International Isotopes Inc.

August 29, 2012

Subject: Request to Amend NR-1235-S-108-S.

BMCY68 BOTTOM OPTION 1 (STANDARD)

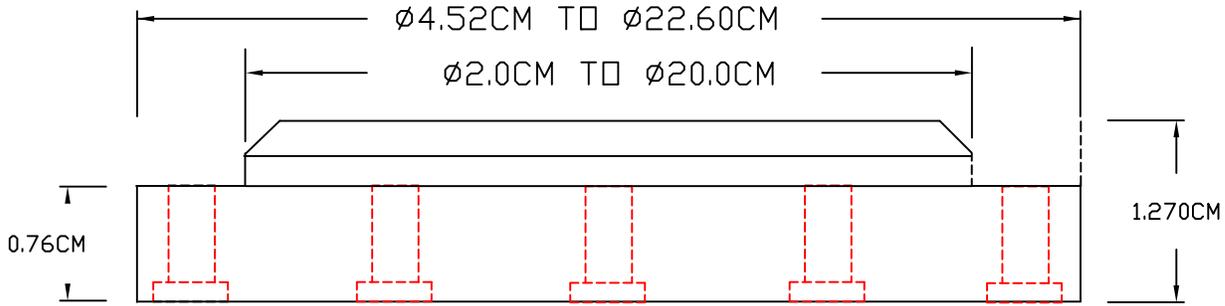
The new drawings that have been provided are more legible and include additional design detail. The BMCY68 Bottom Options drawing now restricts the thickness and configuration of the Model BMCY bottom to 3 options, as described below.

The standard bottom consists of a solid piece of high density polyethylene (HDPE) or equivalent whose diameter is defined by the cylinder body and fixed thickness. Note that in the standard configuration the bottom plate and top plate of the source would be of the same diameter and thickness.

BMCY68 BOTTOM OPTION 2 (SEIMENS ONLY)

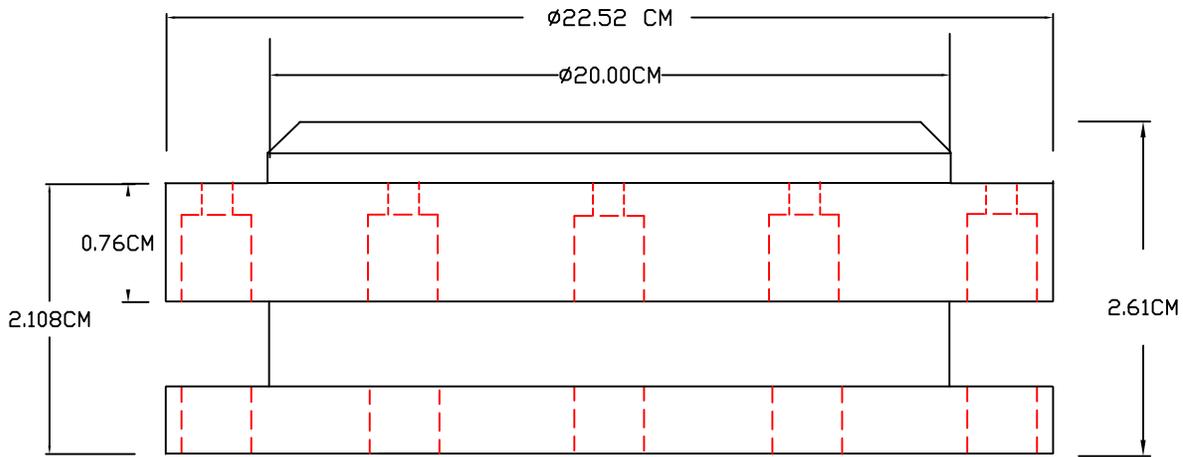
Bottom Options 2 and 3, also fabricated from HDPE or equivalent are within the minimum and maximum thickness of the current Model BMCY-68-DDHH-YY Source drawing (reference Attachment 1 of NR-1235-S-108-S) and are either machined with a groove (as indicated in Option 2) or female threaded connection (as indicated in Option 3) so that the source can be readily attached to the imaging device during calibration and reference testing.
